1. Statutory & Procedural Completeness

1.1 Can total project capacity, container count, or footprint increase after approval without a new application and public hearing?

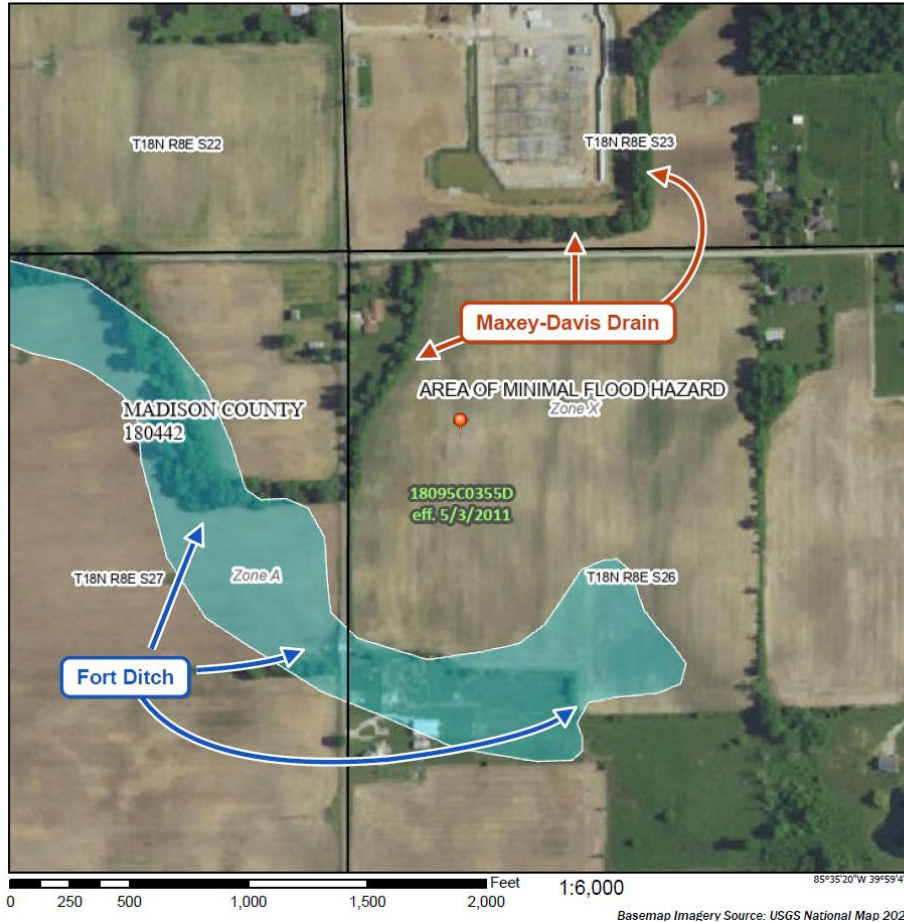
Liberty II — Fort Ditch

Liberty II drains to Fort Ditch, which is located within a mapped floodplain. Stantec's desktop and field delineation classified Fort Ditch as a "Potentially Jurisdictional WOTUS"; a formal delineation has not been conducted, and a USACE determination would be required to confirm jurisdictional extent.

The development does not physically disturb Fort Ditch. Apart from a stormwater outfall connection and a transmission structure, all project components sit outside the floodplain. Provided that the outfall is constructed above the ordinary high-water mark and outside the natural waterway, the work should not require Section 404/401 authorization. A construction-in-floodplain permit from IDNR may be required for the outfall and transmission structure, and any work within the FEMA-mapped floodplain will meet applicable IDNR regulations.

The local USACE office typically does not treat the full development area as the "action area" where the only potential impact is a stormwater outfall of this scale, and this limited interaction does not create a federal nexus for the project.

National Flood Hazard Layer FIRMette

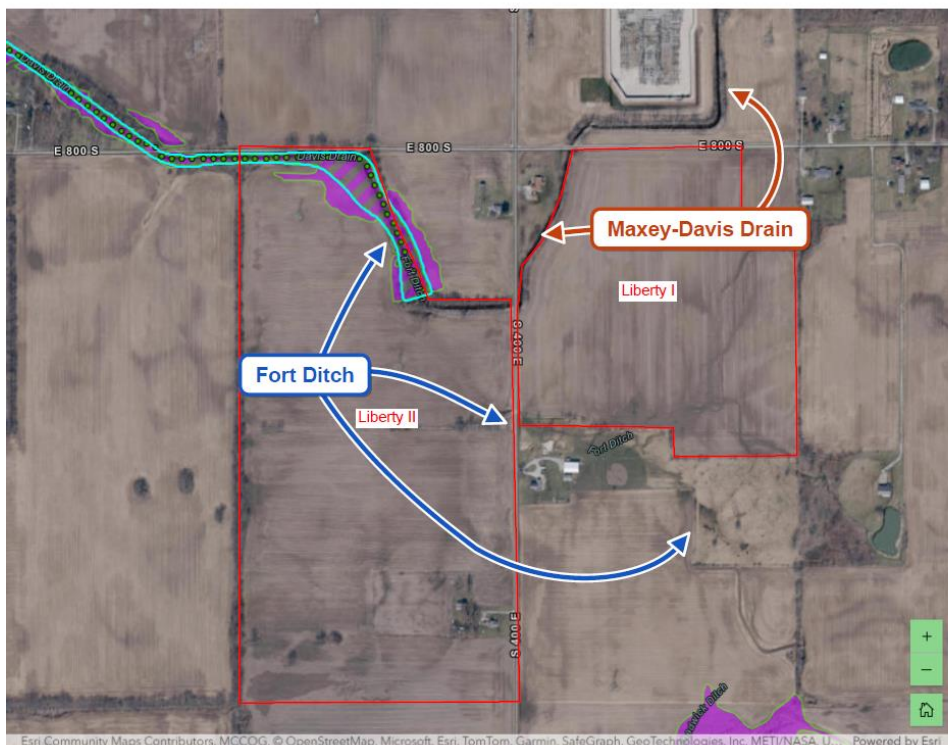
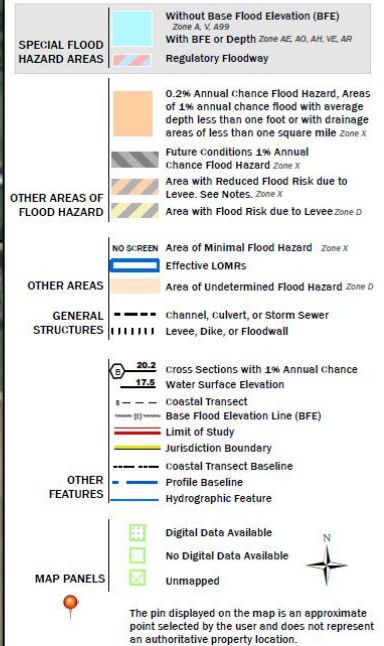
5.2 What are the waterways that the two projects drain to and are they waters of the United States? If so, why don't the projects' interaction with them create a federal nexus?

The images that follow identify the relevant drains, ditches, and mapped floodplains referenced in this response.
